Subject: Re: Upcoming Well Install RTN 1-21489

TOWN OF SHUTESBURY
 SITE PLAN
 66 LEVERETT ROAD
 SHUTESBURY MASSACHUSETTS

Wetland Delineation Overview

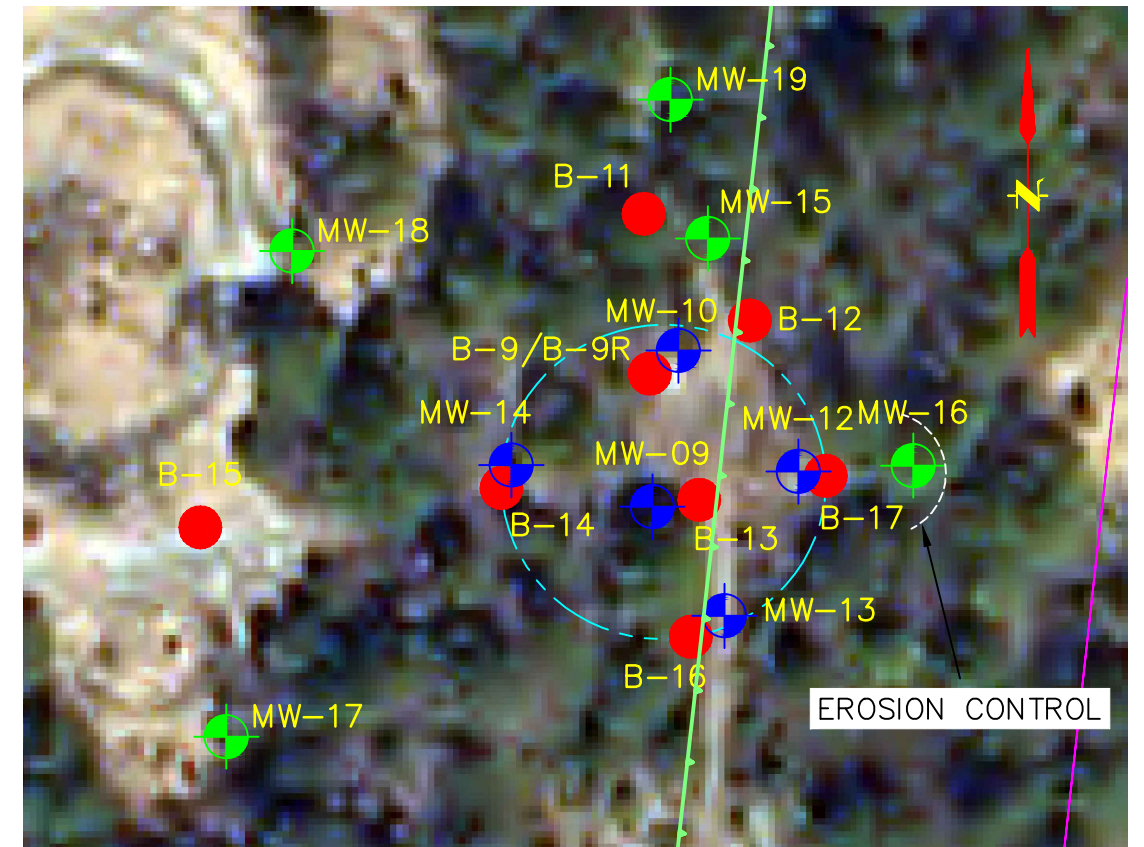
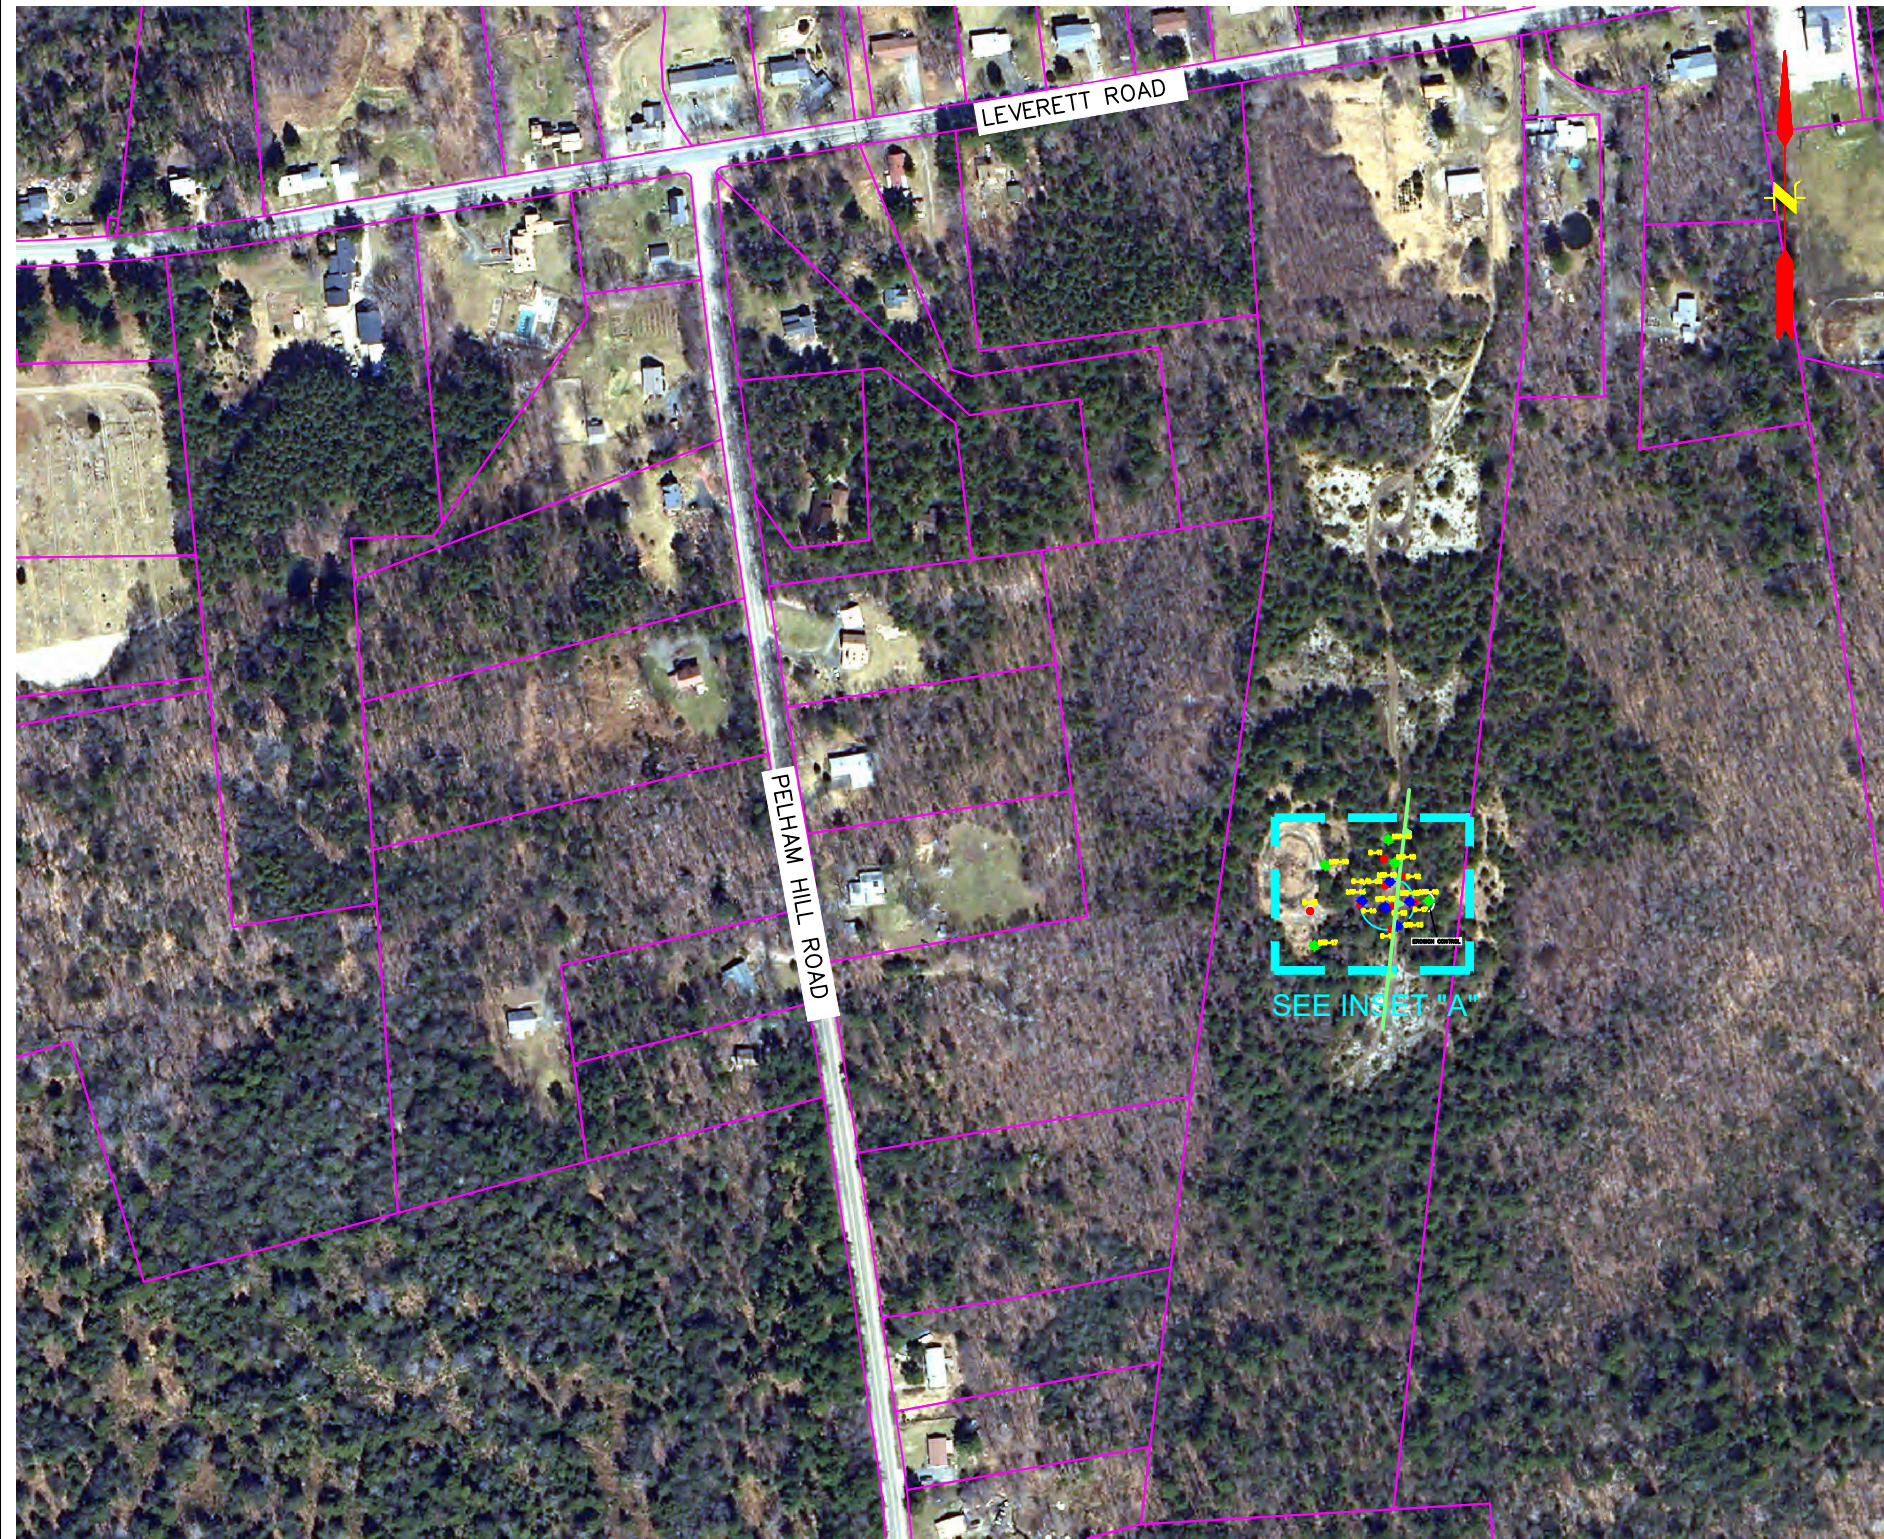
Please see attached. After doing another review of our existing dataset, we have made a slight modification to the location of one of the proposed wells to ensure we have assessed the nature and extent of the release in all directions. You will notice that one proposed well, MW-16 is now being proposed within the 1' no-contest Buffer off of the eastern parcel boundary (it will be > 5' from that parcel boundary). This well is a necessary "step-out" location due to exceedances of applicable regulatory criteria in existing monitoring well MW-12. As indicated on the attached plan, we will employ erosion control between the location of MW-16 and the parcel boundary. Additionally, although the Shutesbury Bylaw does not specifically address minor activities in buffer zone, the proposed installation of MW-16 does comply with the definition under 310 CMR 10.02(g), which defines minor activities as those "that are temporary in nature, have negligible impacts, and are necessary for planning and design purposes (e.g. installation of monitoring wells)".

Thank you for that clarification. This activity is approved with the following conditions:

- No tree removals are approved except for saplings with dbh 6 inches or less;
- No stump removals are permitted;
- Protective matting is used to mobilize the equipment along the wet areas of the access road; and
- Within 24 hours of completing the work, you submit photographs documenting the matting and erosion controls.
